TO:	Planning Office	SUBJECT:	POD2013-00095: Three Chopt Retail at 9911 Three Chopt Road
FROM:	Henrico County Police Division, Community Services Unit	DATE:	September 3, 2013

POD2013-00095

Three Chopt Retail at 9911 Three Chopt Road

Photo A. Shielded wall pack.

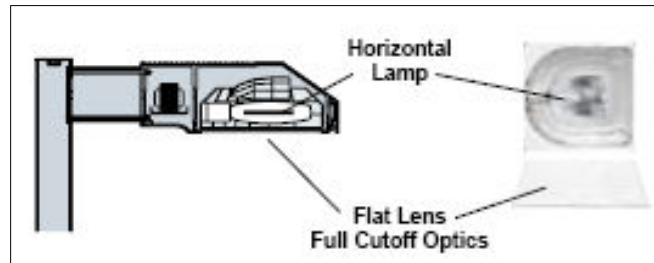
3. All light fixtures need to be full cut-off. See Photo's A and B for examples of full cut-off wall packs and pole lights.
